Coastal Access – Isle of Wight, IOW4 and IOW5

Representations with Natural England’s comments

March 2022

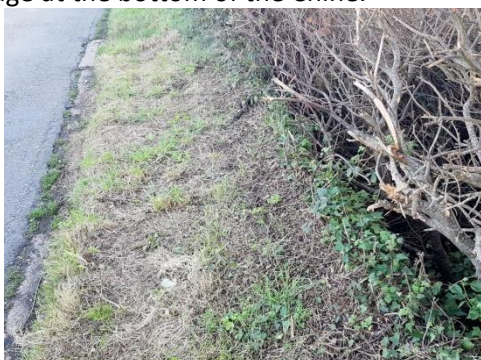
4.5 Map IOW 4d S053 to S058 - The route follows Gore Cliff and uses existing paths to reach Blackgang roundabout. IOW Ramblers **support** this proposal which avoids the busy Blackgang Venue car park.

Map of new route at Binnel Bay and revised attribute table 4.3.1

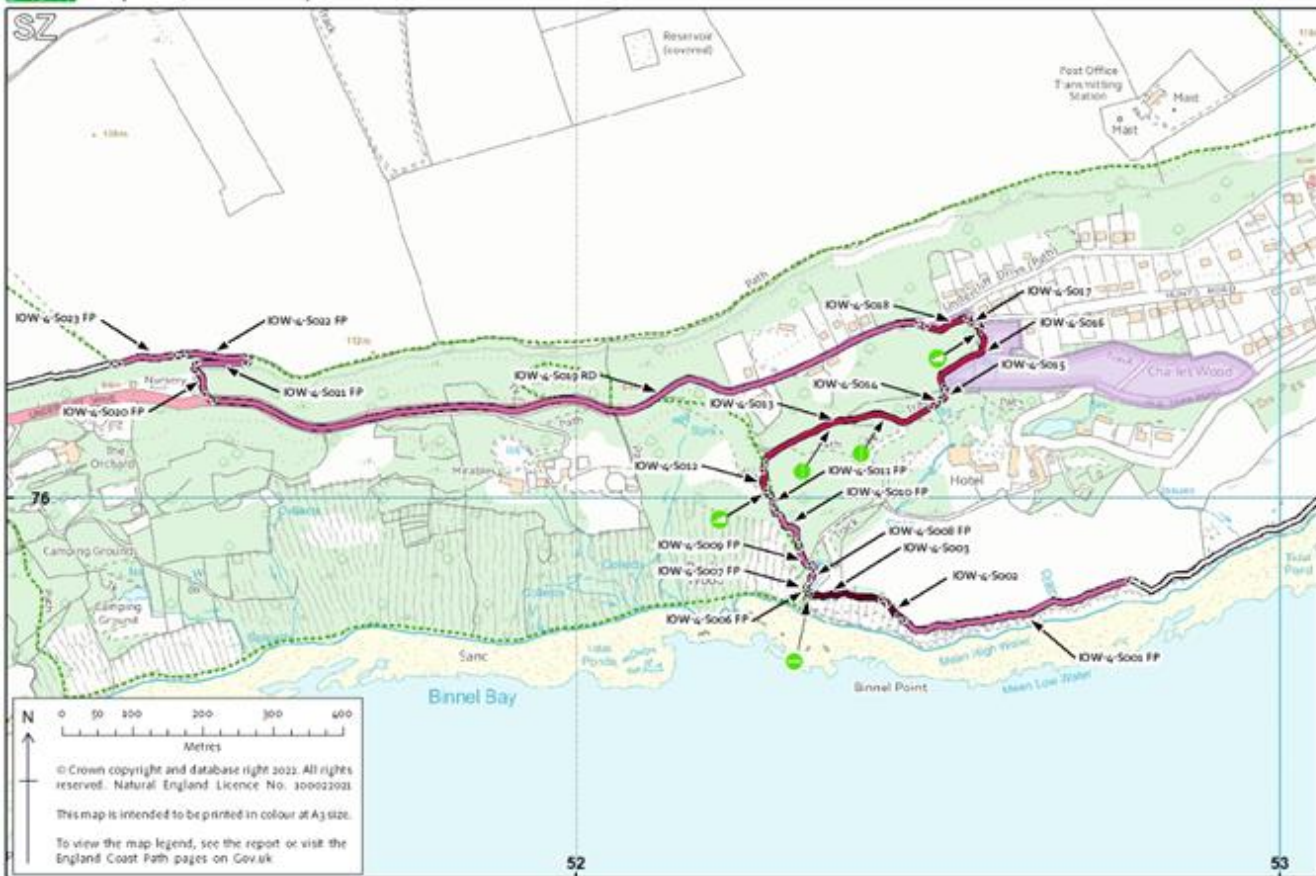
This route is acceptable. However, it initially follows V124 though an area of landslip which will be expensive to reinstate and maintain to national trail standards. A feasible route circa 100m to the east along a field edge and then following existing well used paths would be more sustainable

Natural England has discussed several route options in collaboration with the council, our lead ecologist on the Isle of Wight, and the relevant landowners to come to an agreed new route at this location, avoiding the area lost to erosion (annex 3). The route passes over a small stream so it will require a raised footbridge to cross over it. Despite this, the level of infrastructure needed for this new route is much reduced from the originally proposed route. This new route has sea views as you walk through a quaint woodland and will provide a route which is less susceptible to erosion on this dynamic coastline. We ask the Secretary of State to approve the amended route as set out on the map included in annex 4. Accompanying this map, we have also included a revised entry for table 4.3.1.

Email from Needles Landmark Attractions with IWC map

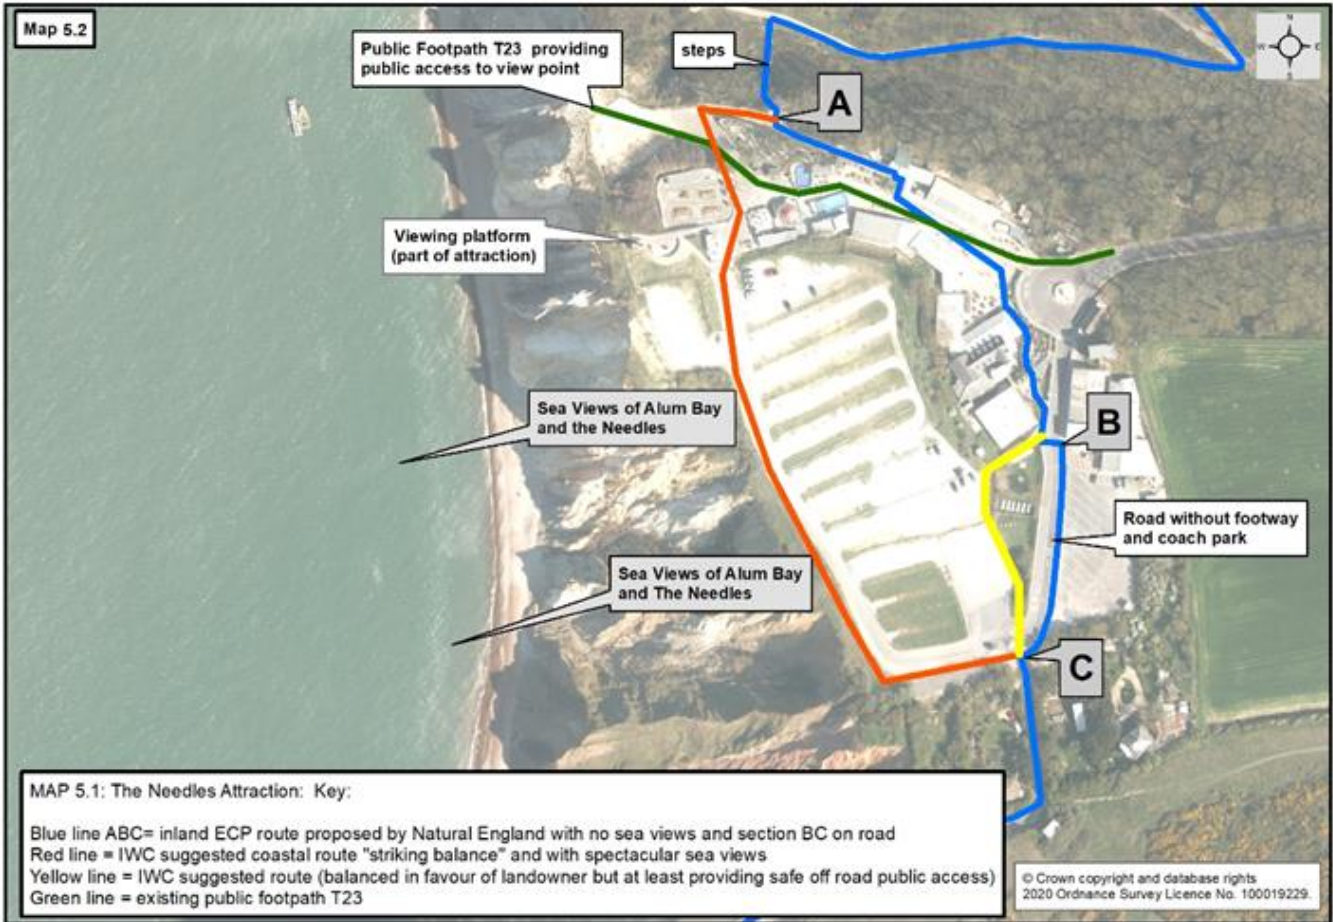
I'm the Health and Safety co-ordinator for the Needles Landmark Attraction, we spoke briefly already as it was I who answered your recent calls. [REDACTED] asked me to review the plans for the proposed route following your conversation yesterday and I am very much in agreement that the route marked in blue on the map would definitely be the safest and most suitable. The red route would unfortunately run up the side of our car park which as you can imagine is incredibly busy in peak times and there is no clear walkway. Similarly the yellow route, whilst slightly better, would also need to cross both the entrance and exit to the car park and in peak times this is accessed by over a thousand vehicles a day. It is also the main entrance to our site from the car

park. The blue route is ideal as it utilises existing paths and pavements, then crosses the road at a marked crossing point and continues along the edge of our coach park. This route gives a tarmacked surface all the way and although it does run along the coach park edge, this area is in fact marshalled in peak season and we tend to have between 8-15 coaches visit a day making for a much quieter route.

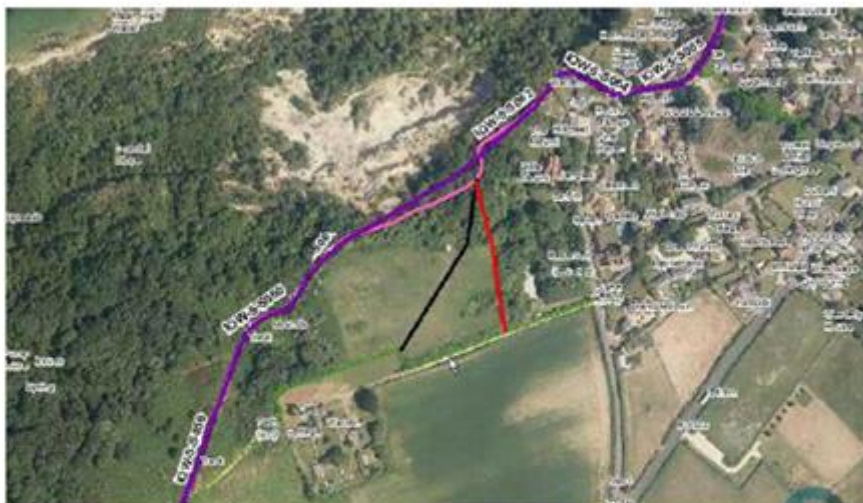
Just to re-confirm that you are happy for the England Coast Path to be routed through your field along the red route on the map below?

I have no problem with clearing a line through the scrub provided SSSI consent is sought and the timing of clearance is between something like 15th August and 28th February. Unfortunately that doesn't give much time this winter and I am afraid we do not have the capacity to do it in our Ranger team as we are already struggling to complete planned winter tasks at the moment.

Map of new route at Headon Warren and revised attribute table 5.3.1

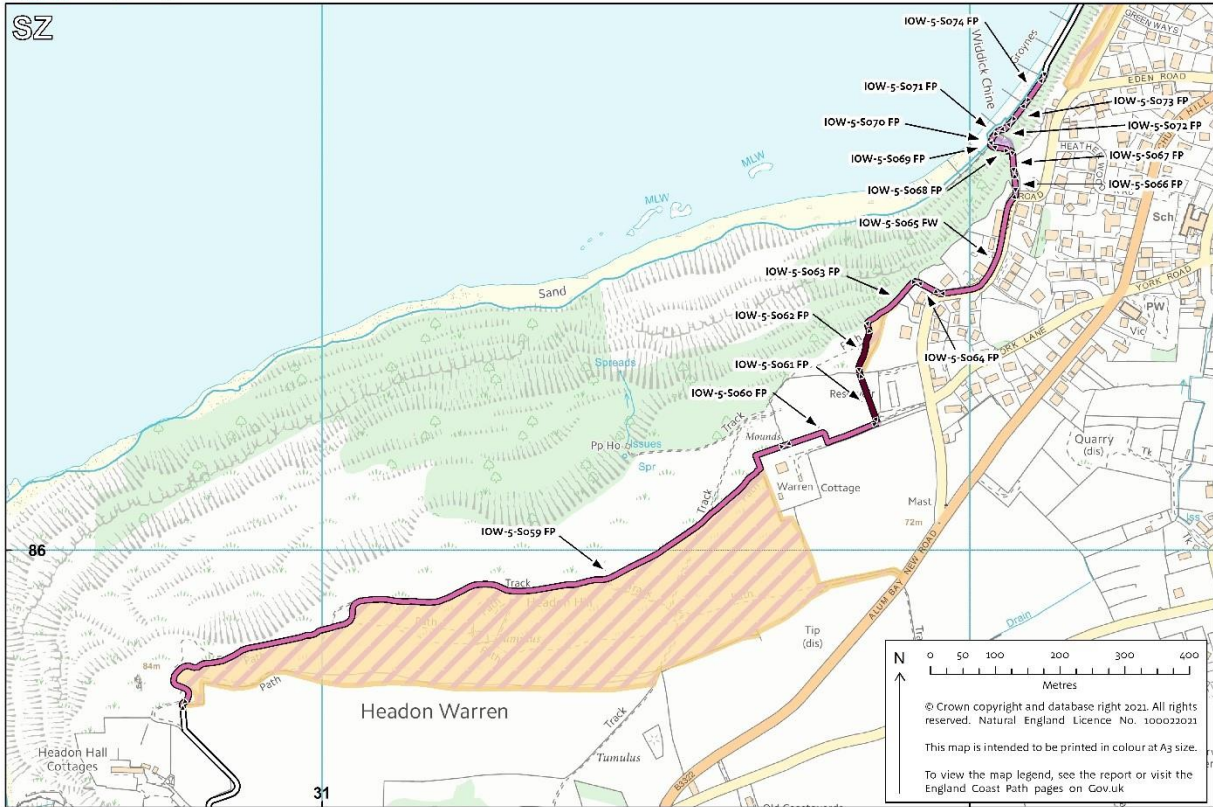
The route here has unfortunately been lost to coastal erosion and a revised route will need to be proposed by Natural England utilising the field north east of Warren Cottage.

Natural England agree with the council's representation that a revised route is required at this location. Natural England has worked with the council and the relevant landowners to agree a new route at this location, avoiding the area lost to erosion (annex 15). We ask the Secretary of State to approve the amended route as set out on the map included in annex 16. Accompanying this map, we have also included a revised entry for table 5.3.1.
